STAFF REPORT

DRCC #: 26-3880C
DATE: July 8, 2026
PROJECT NAME: 62-64 Coryell Street -- Parking Lot Entry Gate
Latest Submission Received: June 24, 2026

PROJECT NAME: 62-64 Coryell Street -- Parking Lot Entry Gate

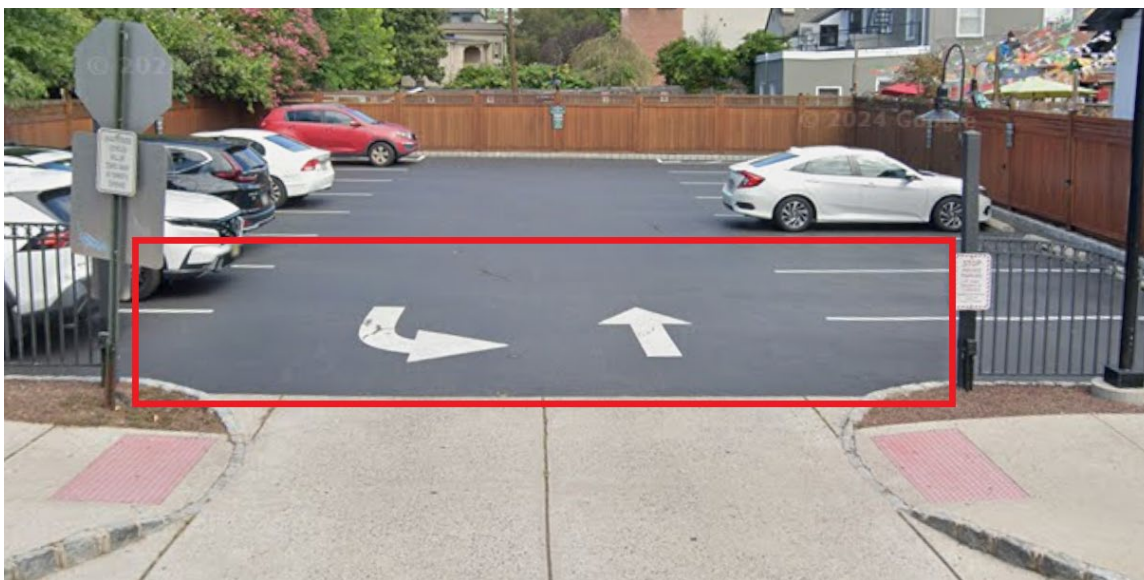
Proposed Project: The applicant proposes to install a gate operator and barrier arm at the Coryell Street entrance to the parking lot to control access to the parking area within (See image of project location below). The project would not result in the creation of any new impervious surface coverage and would disturb 1.5 square feet of land.
